**RE: STEWART AVENUE SANITARY SEWER IMPROVEMENTS AND NORTHEAST
SANITARY SEWER IMPROVEMENTS
PHILIP, SOUTH DAKOTA
SPN #16005/16006**

ADDENDUM NUMBER 1

The following modifications are to be made to the plans for the Stewart Avenue Sanitary Sewer Improvements Project.

S001

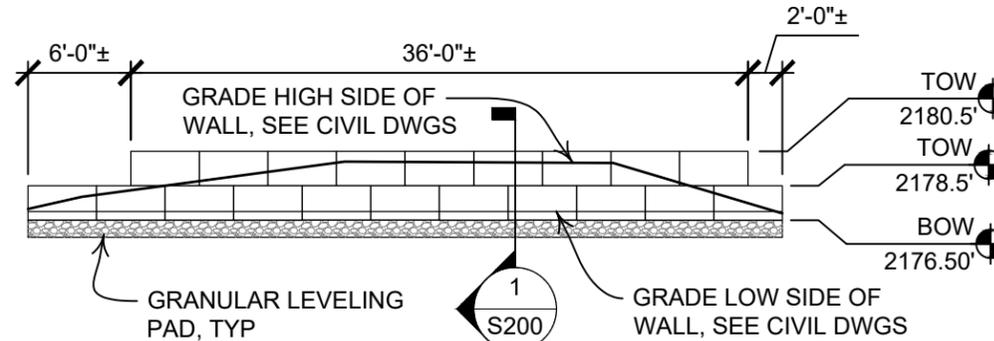
Plan Sheets S001, S100, S200, S201

Remove these plan sheets in their entirety and replace them with the revised sheets dated 10/13/2023, which are attached to this addendum. The sheets were revised to change modular block type to World Block.

- MODULAR BLOCK RETAINING WALL UNITS SHALL BE WORLD BLOCK (24"x48"x24").
- LEVELING PAD SHALL BE A 12" THICK COMPACTED GRANULAR FILL AS INDICATED IN THE STRUCTURAL DRAWINGS. EXISTING IN-SITU FOUNDATION SOILS SHALL BE INSPECTED AND APPROVED PER THE GEOTECHNICAL REPORT PRIOR TO LEVELING PAD PLACEMENT.
- FREE DRAINING BACKFILL MATERIAL SHALL BE A CLEAN ROCK AS INDICATED.
- WALL UNIT INSTALLATION SHALL BE AS PER THE MANUFACTURER'S INSTALLATION RECOMMENDATIONS. ONLY HAND-OPERATED PLATE COMPACTING EQUIPMENT SHALL BE USED WITHIN 3 FEET OF THE WALL TO ACHIEVE CONSOLIDATION. COMPACT BACKFILL AS PER THE GEOTECHNICAL REPORT
